## MEMORANDUM

DATE: AUGUST 24, 2023  
TO: COASTAL PERMIT ADMINISTRATOR  
FROM: LIAM CROWLEY, PLANNING STAFF  
SUBJECT: CDP\_2022-0018 (MCNABB) CLARIFICATIONS

OVERALL SITE MAP  
 ERIN MCNABB  
 32601 ALBION RIDGE RD  
 ALBION, CA

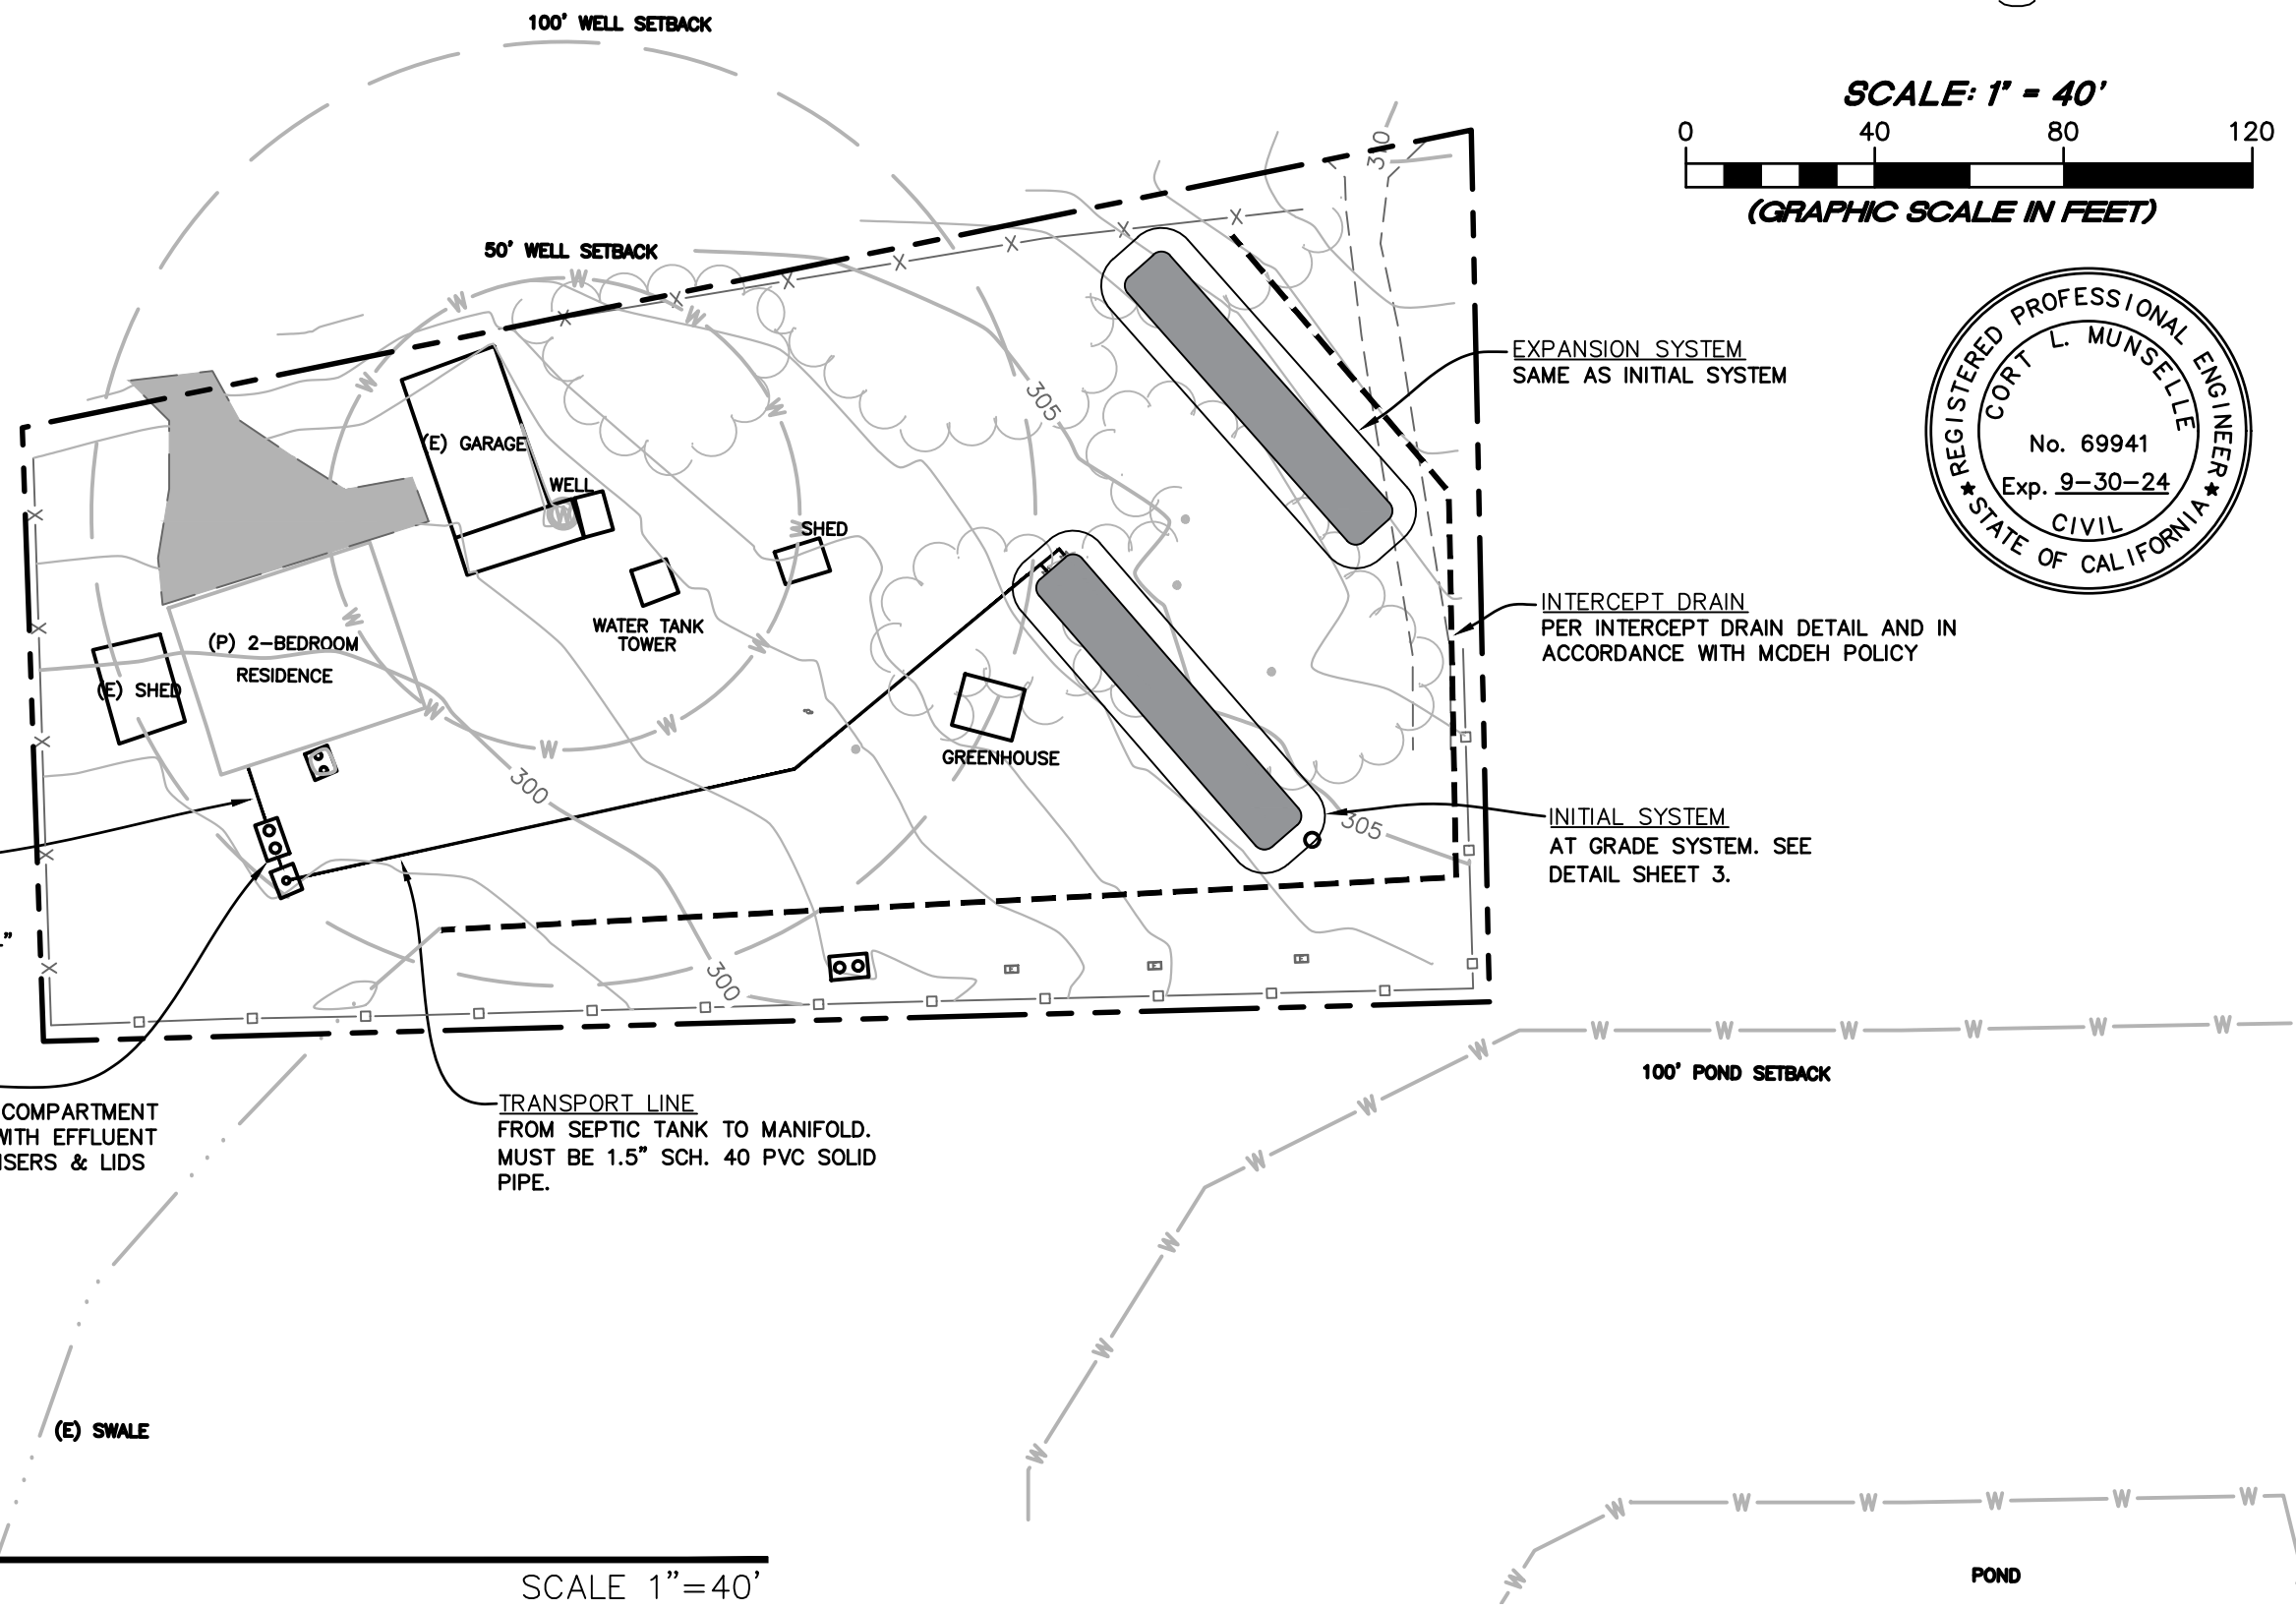
**Takings Analysis:** As shown on the attached Septic System Site Maps and Rare Plant and ESHA Areas Map, several elements of the septic system would be located within the identified Wetland ESHA and/or within the buffer areas for either the *Hosackia gracilis* or *Hesperocyparis pygmaea* individuals. Because the septic system is associated with the proposed residential development, which is not a permitted use within Wetland ESHA, the proposed septic system would be inconsistent with the LCP, and the finding contained in Section 20.532.095(A)(1) cannot be made. Therefore, the proposed septic system must also be analyzed to determine if denial would result in a taking. The proposed septic system is inherently tied to the rest of the proposed development because it is required by the Environmental Health Division and Coastal Element Policy 3.9-1 to support the residence. As such, staff finds that the same reasonable investment-backed expectation to demolish and reconstruct a single-family residence applies to the development of a septic system which supports the new residence. Because the proposed residence has been determined to be of appropriate size when compared to nearby development, the appurtenant 2-bedroom septic system is similarly appropriate. Each of the surrounding properties analyzed within the staff report were approved under a Coastal Development Permit, and each had associated septic systems which must have been determined to be adequate to support their respective development under Coastal Element Policy 3.9-1. The LCP wetland regulations interfere completely with development of a septic system because residential development is not permitted in a wetland and the entirety of the parcel was determined to be a Wetland ESHA. Denial of the project, including the proposed septic system, would appear to deprive the owner of all economically viable use of their property for the same reasons explained in the staff report.

**Environmentally Sensitive Habitat Areas:** As shown on the attached maps, several elements of the septic system would be located within the identified Wetland ESHA and/or within the buffer areas for either the *Hosackia gracilis* or *Hesperocyparis pygmaea* individuals. With regard to the Wetland ESHA, there is no feasible less environmentally damaging alternative for the septic system. A septic system supporting the proposed residence must be approved to avoid a taking. As the entirety of the parcel has been determined to be a Wetland ESHA, there is no other area to place the septic tank, leach fields, or other elements of the system without encroaching upon the Wetland ESHA. With regard to the rare plant ESHAs, there is no less feasible environmentally damaging alternative because the location of the septic system is constrained by regulatory buffers, existing structures, shape, and size of the parcel. As shown on the attached maps, the proposed sewage line and septic tank are located outside of the 50-foot rare plant ESHA buffers. The proposed transport line and leach fields would be located within the 50-foot buffers. However, any other orientation or site of the transport line and leach fields would either be located within the 50-foot buffers or would not meet Environmental Health's requirement that the leach field maintain a 100-foot setback from the well.

- a. A 50-foot buffer shall be maintained between the project site, including construction activities, and the two (2) populations of *Hosackia gracilis* (harlequin lotus) as shown on Map #9 of the 'Biological Resources Assessment and ESHA Analysis', except that leach fields may be constructed in the location depicted on the site plan for septic permit SP24077.

- b. A 100-foot buffer shall be maintained between the project site, including construction activities, and the two (2) *Hesperocyparis pygmaea* (pygmy cypress) trees as shown on Map #9 the 'Biological Resources Assessment and ESHA Analysis', except that leach fields may be constructed in the location depicted on the site plan for septic permit SP24077.

**DETAILED SITE MAP**  
**ERIN MCNABB**  
**32601 ALBION RIDGE RD.**  
**ALBION, CA**

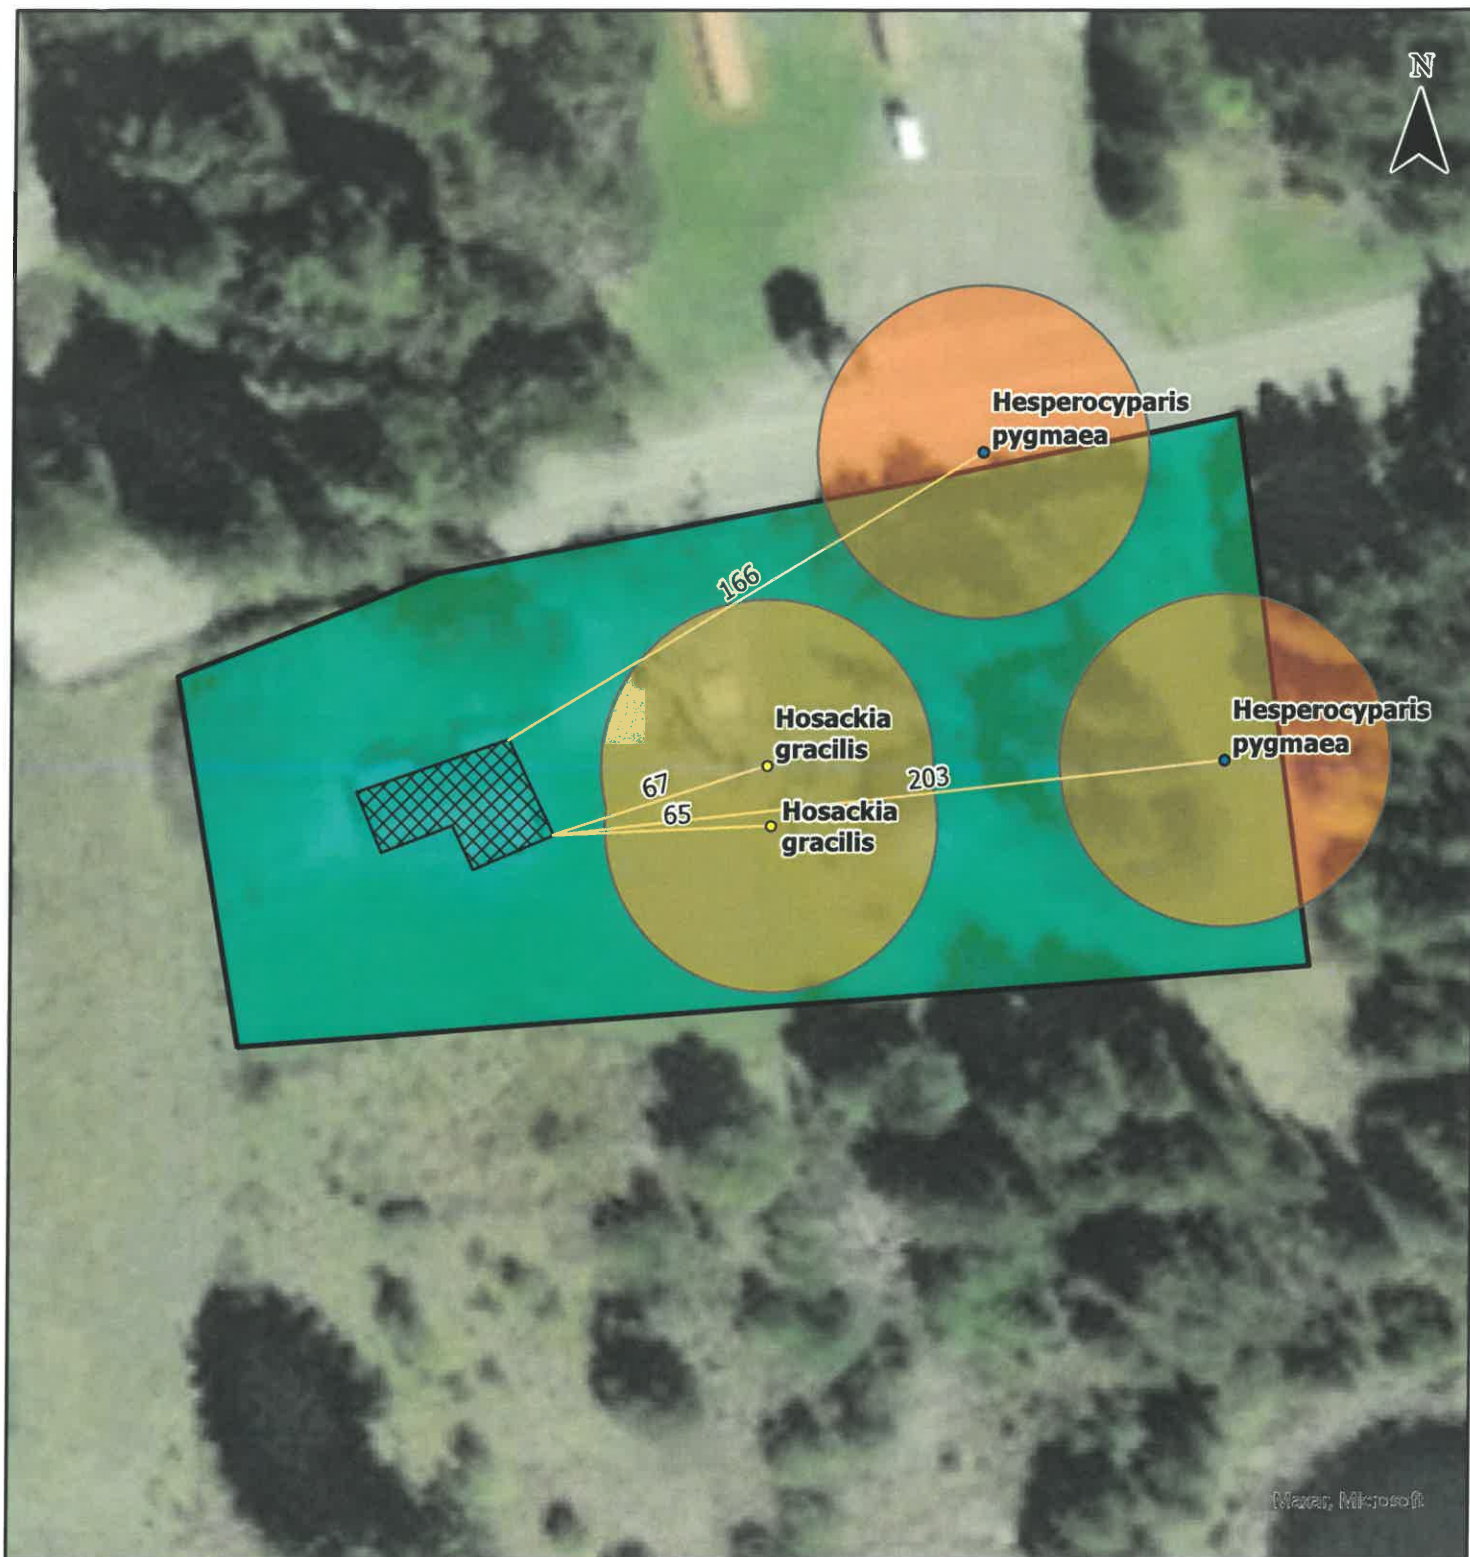
The proposed septic system may result in the removal of wetland vegetation. To adopt all feasible mitigation measures capable of reducing this, staff recommends an additional condition of approval. As the potential impacts to the wetland would occur only from temporary construction over an area of less than 0.25 acres, a restoration plan with a mitigation ratio of 1:1 would be appropriate if wetland vegetation does not recover to comparable size/age class within 12 months from initial disturbance. This would ensure compliance with the LCP to the extent feasible even though the proposed septic system must be approved to avoid a taking regardless of its LCP inconsistencies.

- c. To the maximum extent feasible, only work within the existing footprint of the house site shall be conducted, the stilts and perimeter foundation shall be used, and the wetland plants within the existing perimeter foundation shall not be removed or disturbed.
